From: "Gery Wilkowski" <gwilkows@columbus.rr.com>
To: "Debby Jackson" <DAJ1@nrc.gov>, "Tanny Santos" <cxs3@nrc.gov>, "Rob Tregoning" <rlt@nrc.gov>, "Wally Norris" <WEN@nrc.gov>, "Shah N. Malik Ph. D." <snm@nrc.gov>
Date: 9/12/02 5:55PM
Subject: Additional thoughts on D-B head crack testing

A: Analyses of Flawed Cladding (Davis Besse)

- B: Experiments of Flawed Cladding (similar to Davis Besse)

Figure 1 Fixed-grip SEN(T) specimen
(Photo shows typical 304 stainless steel specimen, sketch does not show side-grooves.)

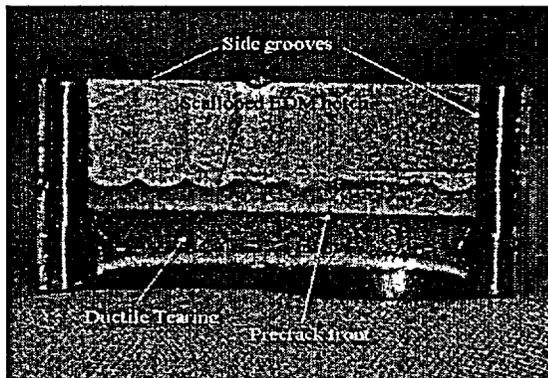
For this problem you would need to do SEN(T) specimens in a fixed-grip condition to simulate surface crack constraint conditions. Below figures show how we did that in some past piping work. Blunt side-grooves were needed to get a straight crack front. We did it with a/t of 0.15, 0.25, and 0.50 in past piping work with 0.3" thick specimens. (Bend-bar specimens would not give similar constraint conditions to the surface crack in the cladding.) - Gery
